RICOH Modification Bulletin

Model: PRIPORT	GOLD	Date: 30-Jun-97	No: 01	
Modified Article:	Parts Catalog		Prepared by:	111/1
From: Priport Serv	ice Planning Section		H. Kokubo	To floring
Classification:	☑ Parts catalog correction☐ To facilitate assembly☐ Part standardization	☐ Vendor chang ☐ To improve re ☐ Other (_ ,	t standards)
Model Name: Ricoh VT2250/VT2 SVN 3250DNP	240, Gestetner 5329(L), RexRo	otary 1254(L), nas	shuatec CP329(L), ABD	ICK 6560,

Model: PRIPORT GOLD Date: 30-Jun-97 No: 01

30. DRIVE SECTION 1 (C226), PAGE 66

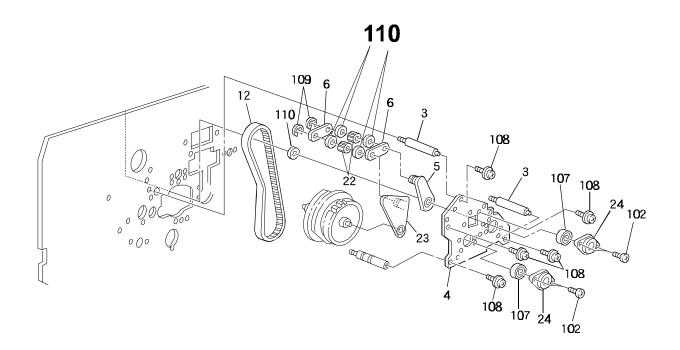
Add index number 110 (four washers) as shown below:

33. ELECTRICAL SECTION (C226), PAGE 72

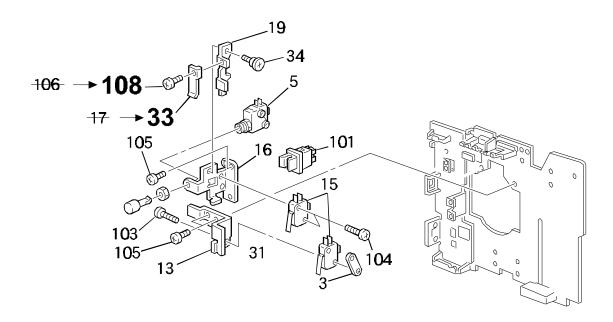
Correct index numbers 106 and 17 as shown below:

- $106 \rightarrow 108$
- $17 \rightarrow 33$

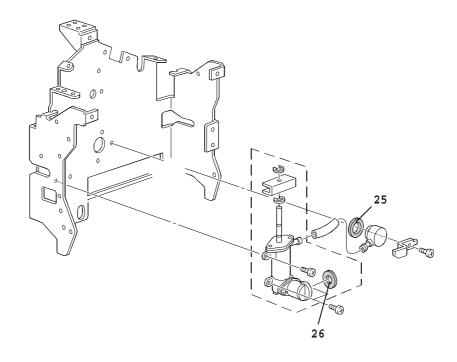
Changed Description and Part Number

Incorrect Part Number	Correct Part Number	Description	Qty	Int	Page	Index
C2004826	08080021	Rubber Ring	1	-	45	25
C2004827	C2004826	Pump Rubber	1	-	45	26

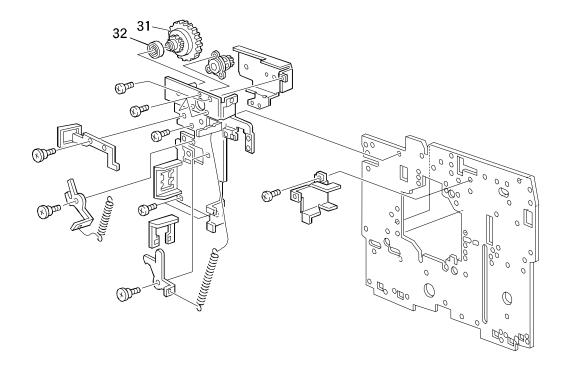
The width of the oil damper gear (scanner) has been increased by 2 mm to reduce the load on the gear wheel and ensure the gear is not damaged.

3				
Old part number	New part number	Description	Q'ty	Int	Page	Index
H5213117	H3073117	Gear – oil damper	1	X/O as a	77	31
, L	H5223118	Collar – oil damper	1	set	<i>77</i>	32
H5213118 —	H3073117	Gear – oil damper	1	X/O as a	<i>77</i>	31
	H5223118	Collar – oil damper	1	set	77	32

Note: Replace the oil damper gear and collar together as a set
